REGULAR MEETING OF THE PLANNING COMMISSION

Monday, July 01, 2024

TOPIC Site Plan Discussion: VLO-24-02 (44 E. Flint) Mixed-Use Development

Subject: VLO-24-02 44 E. Flint, Site Plan Review #1

Sheet Title:
Architectural Site Plan

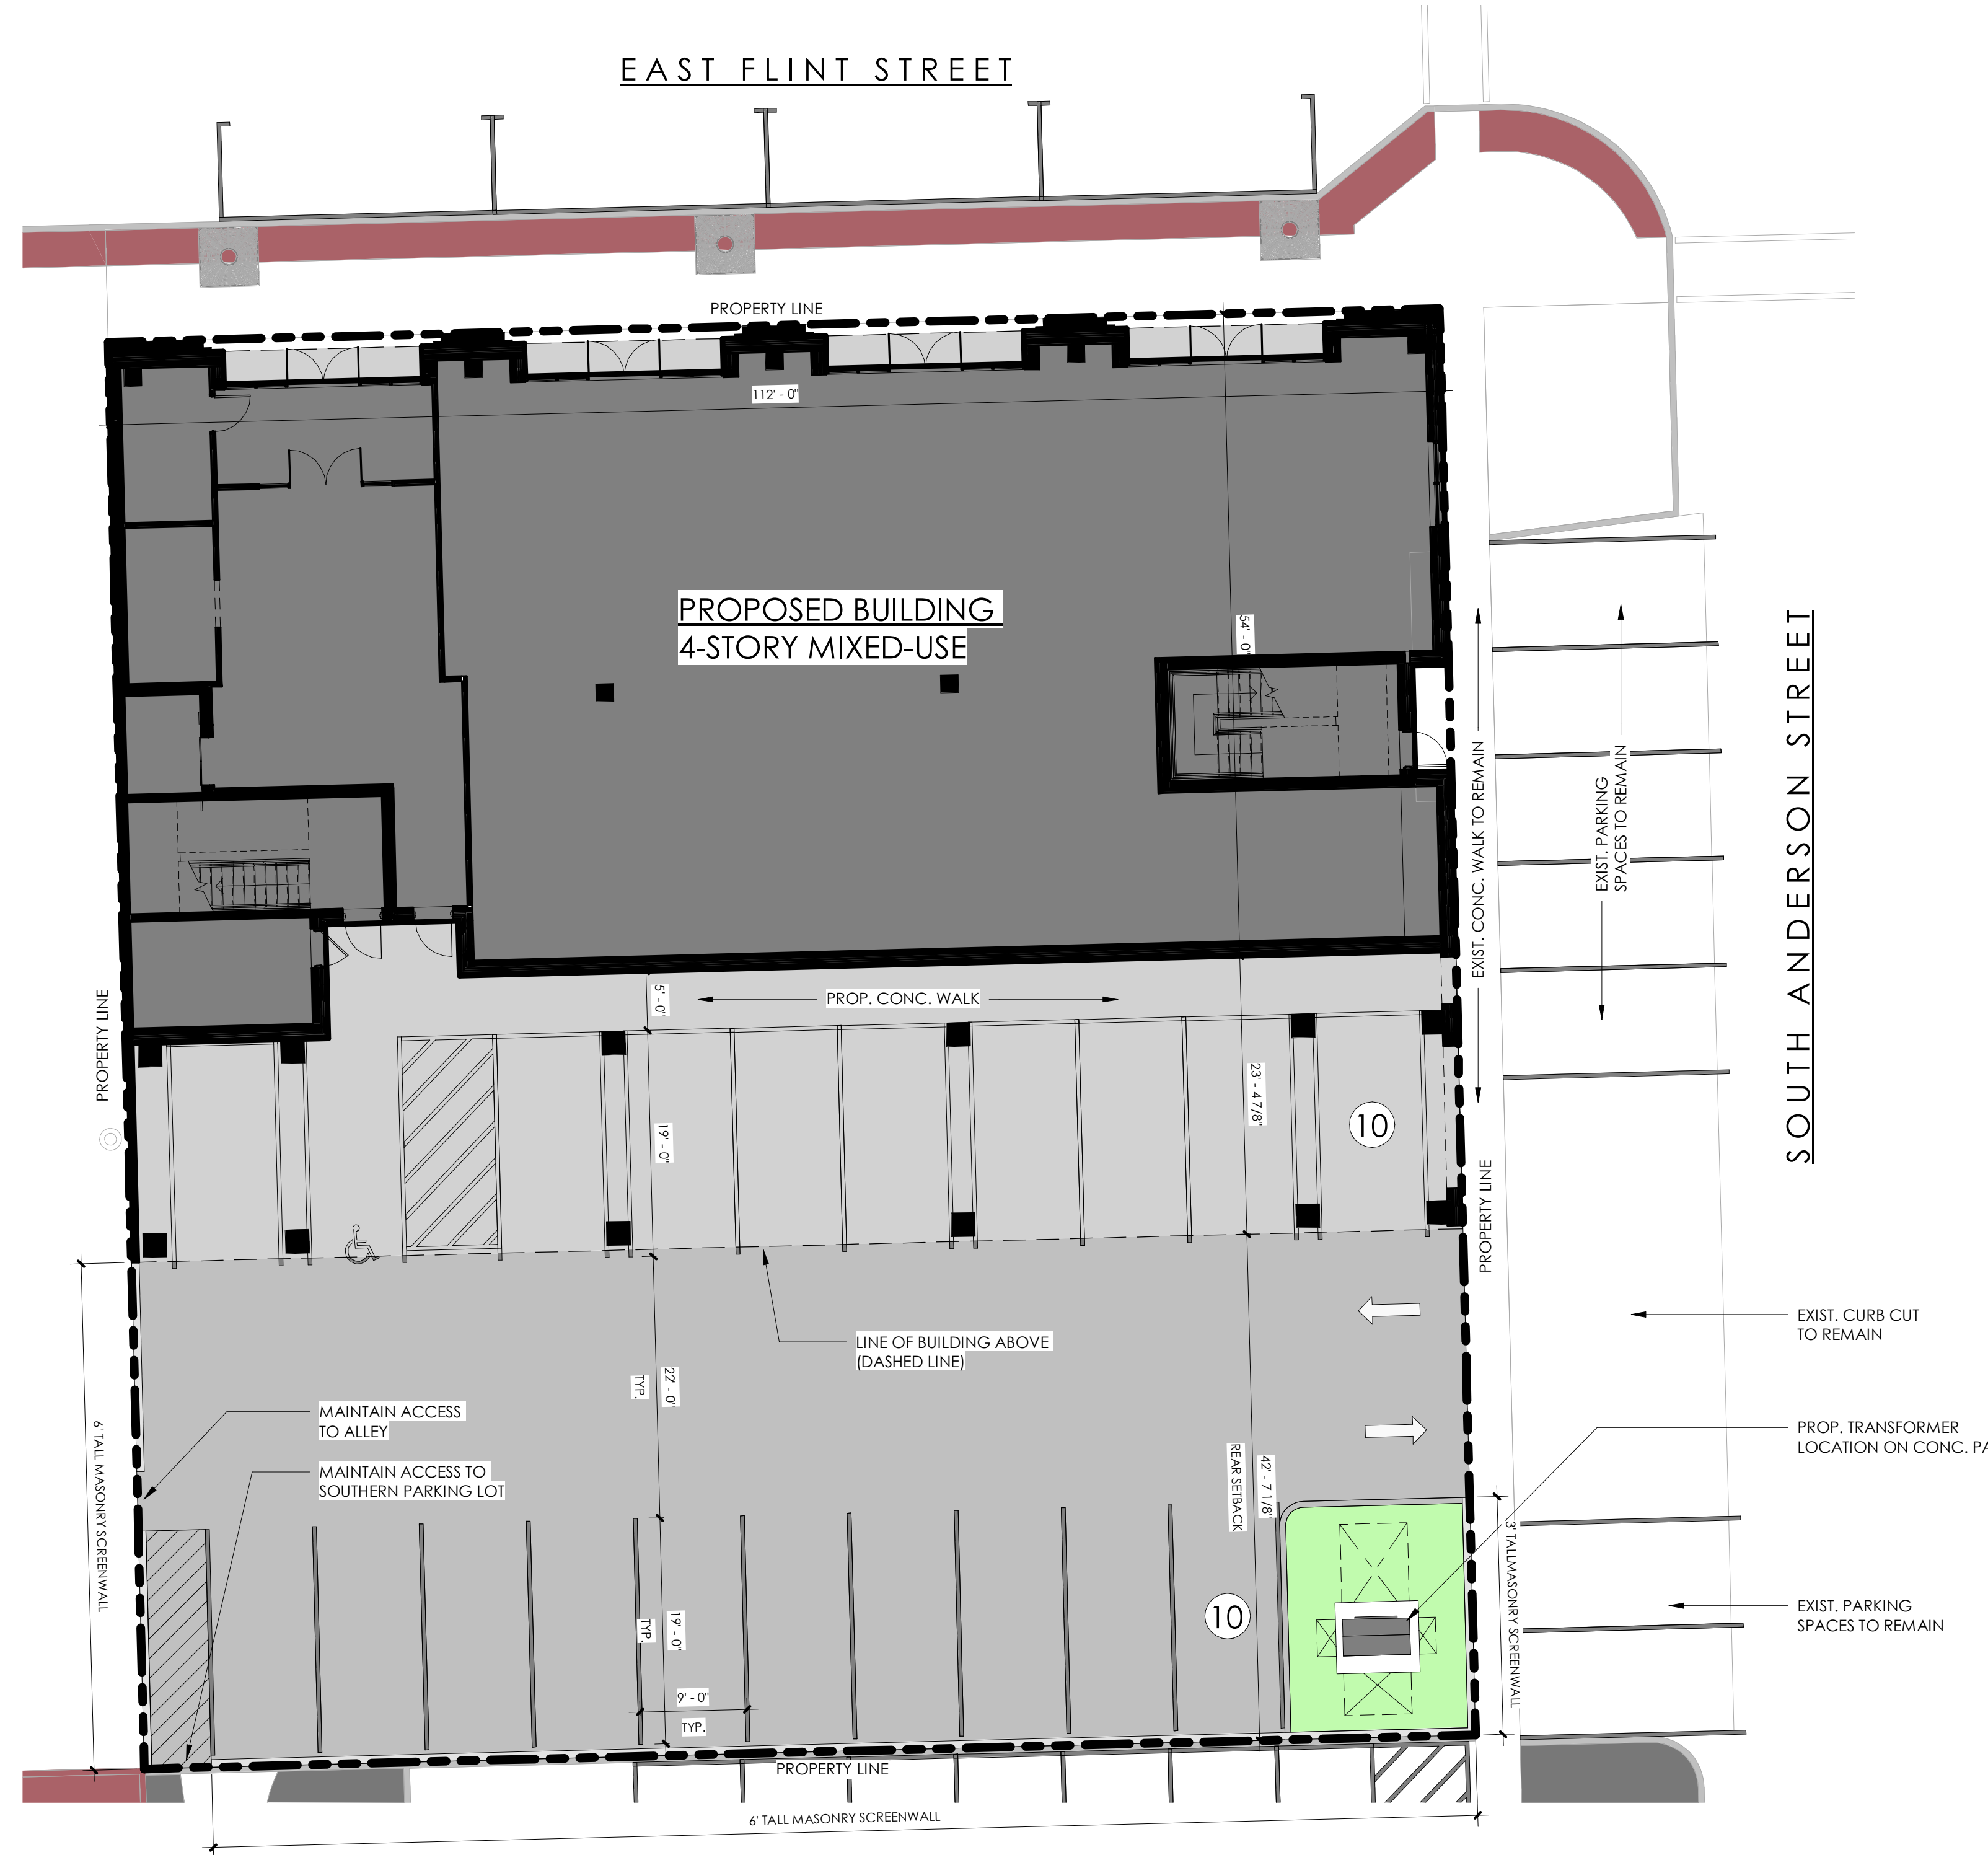
- Signature and seal of the design professional
- 1" to 20' scale and graphic scale
- Proposed grade changes and surface materials – it is recommended that the final topography and architectural site plan be combined on a single sheet.
- General landscape plan – street trees, planters, and screening of mechanical equipment.
- Existing and proposed utilities.

- e. *Screening shall be compatible with the architectural design of the building.* The plan notes that the transformer and parking lot will be screened with a masonry screening wall on two sides; the applicant must provide a note and cross-section indicating the screening wall material will match the building.

The site plan depicts renderings with landscape planters and street trees along Flint; a general landscape plan is required to identify these elements. The three existing street trees must be protected or replaced if removed. It is recommended that additional right of way landscaping be provided at the vehicle entrance to the site, just south of the five on-street parking spaces, within a curbed landscape bed to assist with stormwater management, protect the existing light pole (remove bollards), and enhance the area with additional foliage and screening of the building and parking. As discussed further below, it is also recommended that the applicant replace the two southern on-street parking spaces with additional landscaping, including one street tree, to permit clear vision while exiting the site and creating a defined, enhanced driveway – two additional off-street parking spaces are proposed along Flint St. as part of this project.

- b. **Dimensions and Layout.** The 20 off-street parking spaces are entirely within the site, dimensioned at 9 ft. x 19 ft. with a 22-ft.-wide maneuvering lane; a scale must be provided to verify all site plan dimensions. As proposed, passenger parking is tight, particularly for the two west-most parking spaces, which run a high risk of conflict with the alley wall, building columns, and/or other parked vehicles. Although the required off-street parking is shown, we recommend that the Planning Commission grant a waiver for a reduction of up to 5 spaces, effectively requiring 1.5 spaces per dwelling unit. In doing so, additional maneuvering (and landscaping) space would be afforded; this may also free up space for an alternative trash enclosure location as discussed below. Further, as mentioned, nothing shall preclude the applicant from pursuing cross access opportunities with neighboring parcel owners.

- c. **Loading Space.** One 10 ft. x 50 ft. loading space is required (Sec. 14.05(C)) for retail space between 2,000-20,000 square feet; however, loading should not be closer than 50 ft. to a residentially zoned or used parcel. With a residential use across Anderson and the site itself being mixed-use residential, we recommend the loading requirement be waived or lessened (i.e., 10ft. x 25 ft.) by the Planning Commission; otherwise, this must be showed on a revised plan.

- d. **Trash Enclosure.** A dumpster is not shown on the site plan. The DDA owns the parking lot to the south and has indicated an interest in working with the applicant to establish shared dumpster use and access within its lot. It is encouraged that these discussions continue; the potential location of the shared dumpster (and screening) must be shown on the plan and a signed shared access and use agreement shall be executed prior to final approval. An alternative trash enclosure design shall be prepared in the event a shared dumpster cannot be achieved.

1. The Site plan must be prepared superimposed on the topographic information, indicating the property lines (with bearings and distances), all existing easements, and all existing and proposed utilities.

2. No scale is indicated on the Site Plan title block.
3. Show proposed dimensions between building wall and property lines. A temporary construction easement may be required from adjacent private property owner.

5. Parcel 09-02-481-007 is incorrectly labeled as -008.
6. The proposed pavement material for the parking area must be indicated on the Site Plan.
7. No storm water management is indicated on the site plan. No surface area from a parking area shall be permitted to drain on to adjoining property or across a public sidewalk.

8. The proposed building is placed over the existing electrical easement (L. 15526, P. 468, 470, 472). Provide information regarding the easement that permits the construction of a building within the easement.

9. An existing sanitary sewer easement (L7058, p 371) is indicated within the proposed building footprint. Provide information regarding the easement that permits the construction of a building within the easement.

17. No method or location for trash removal is indicated on the site plan.
18. The presence or absence of wetlands and / or 100-year floodplain must be noted on the Site Plan.

Plan View
Scale - 1" = 10ft

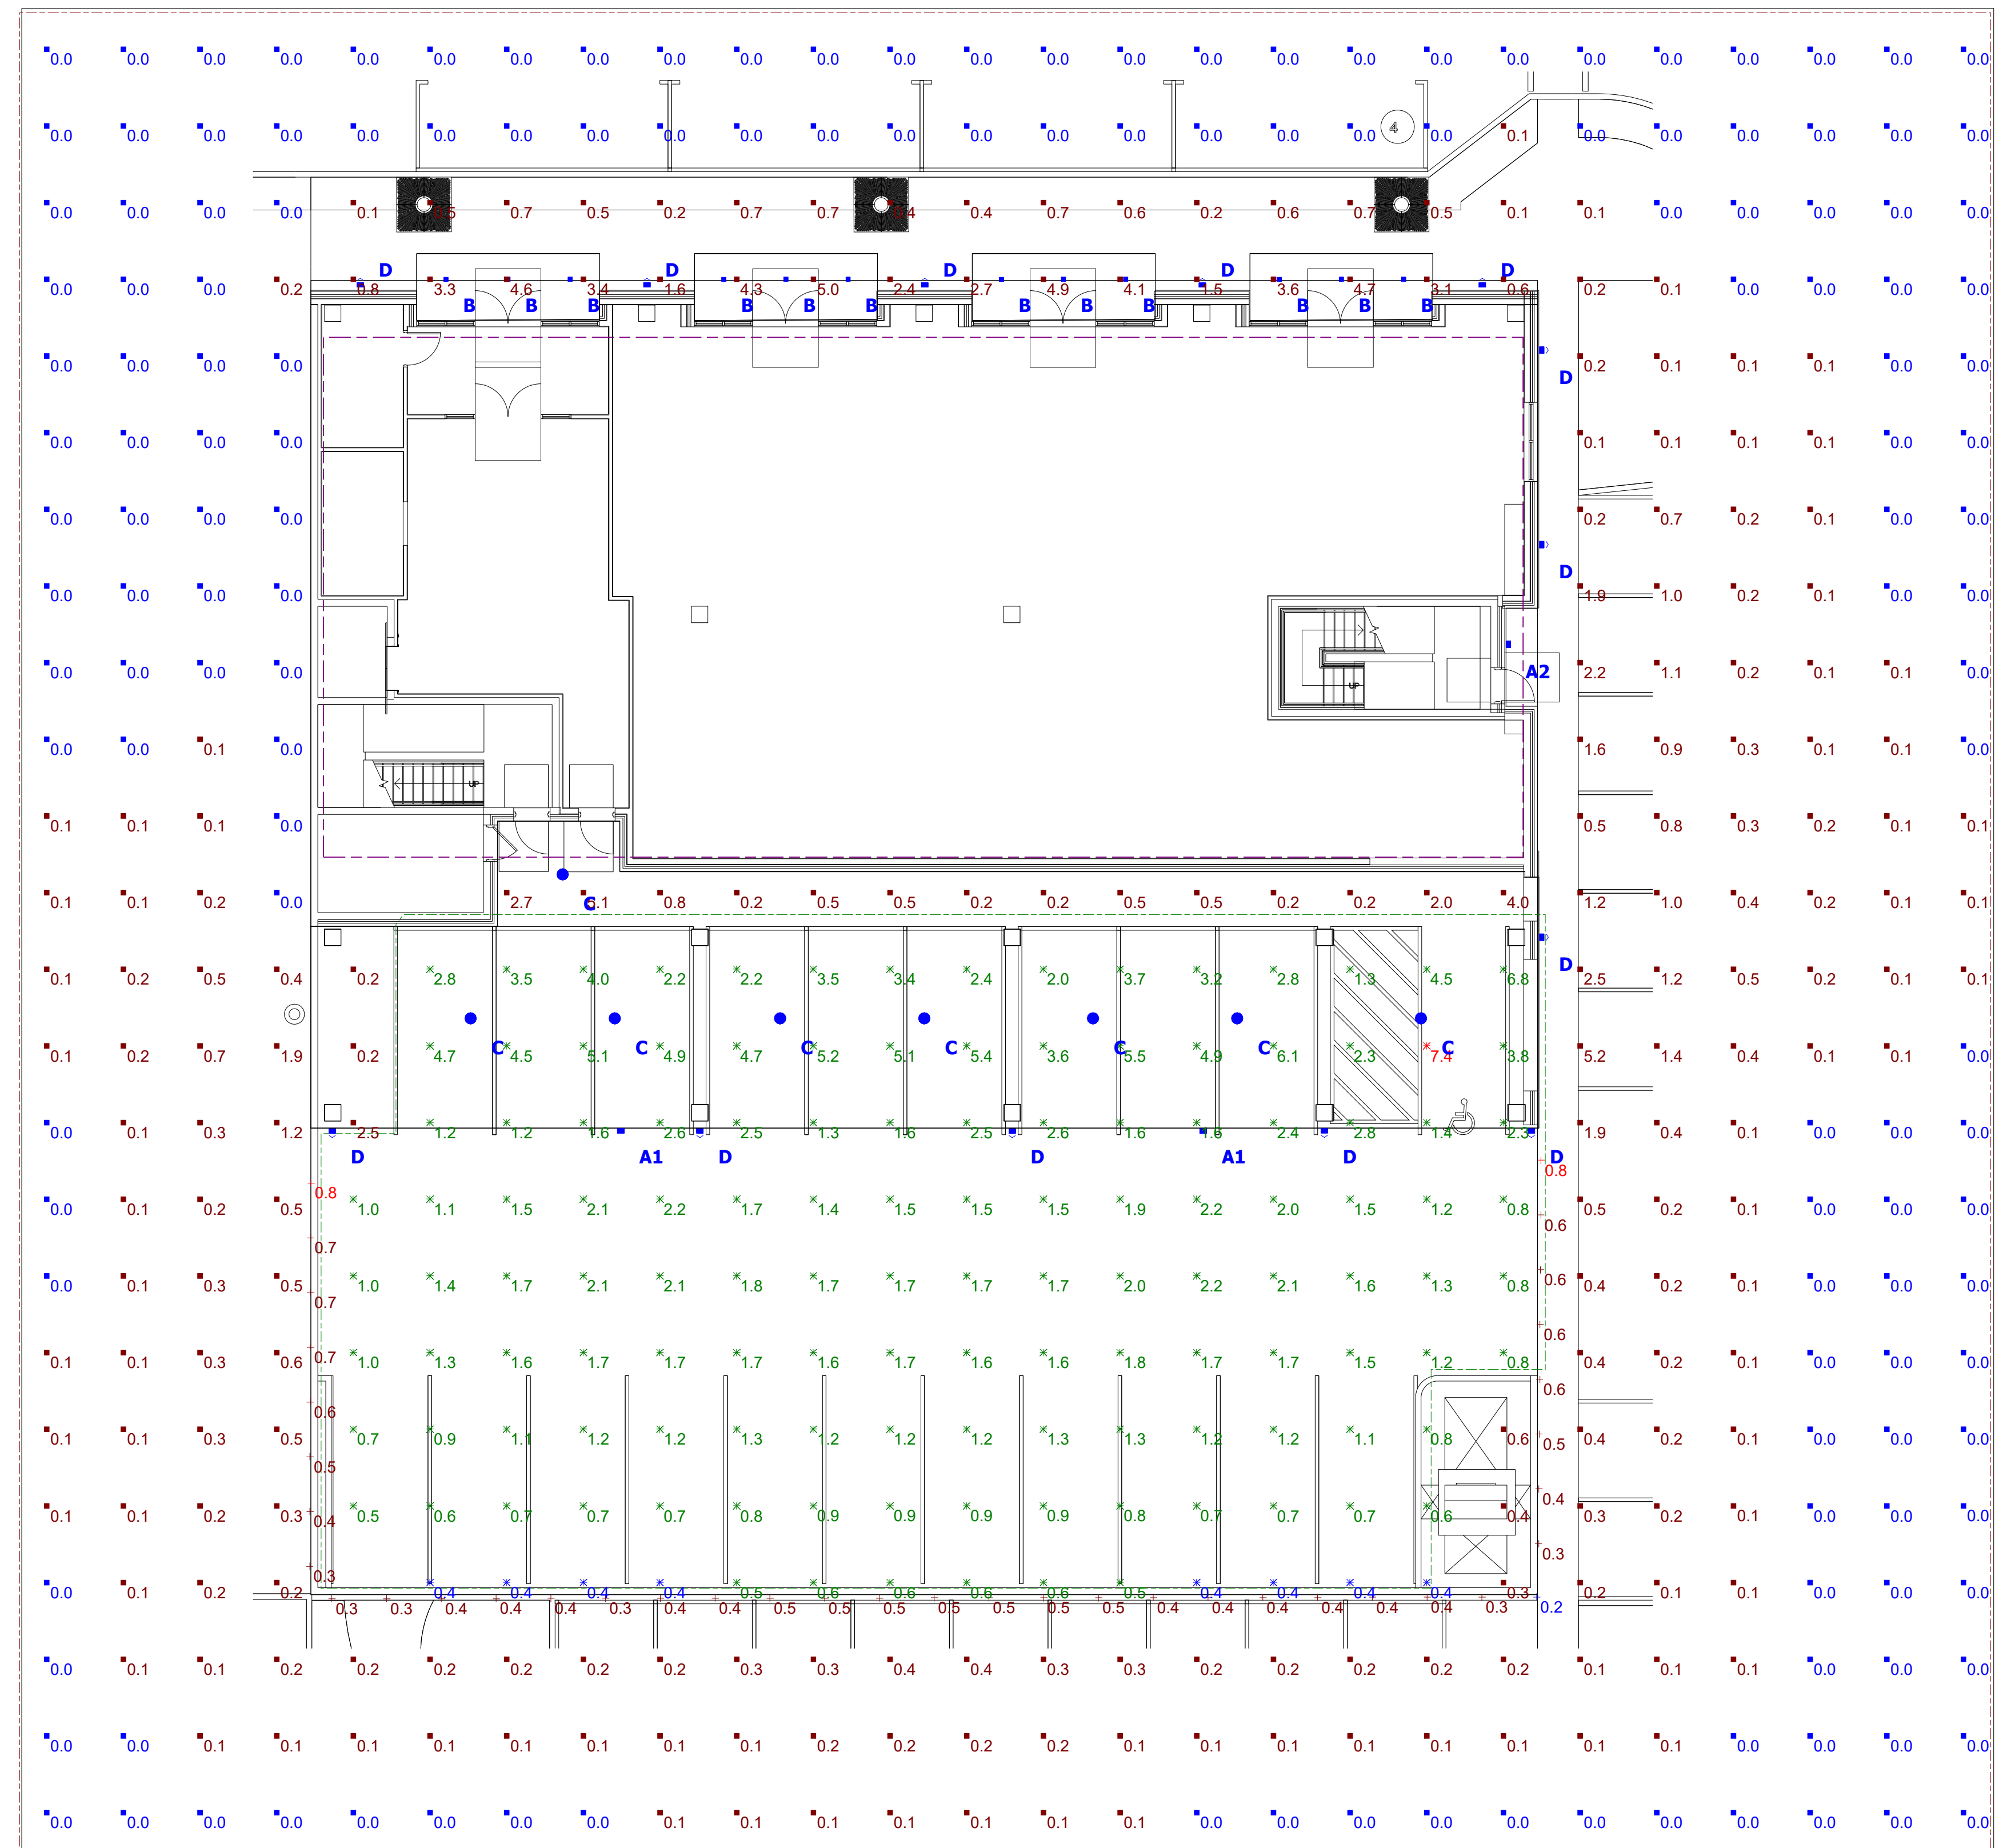
The Planning Commission may modify lighting requirements in considering possible off-site impacts and the character of the proposed use. We recommend that the lighting along Anderson be reduced, to minimize off-site impacts. We recommend the Planning Commission grant a waiver for proposed illumination along Flint.
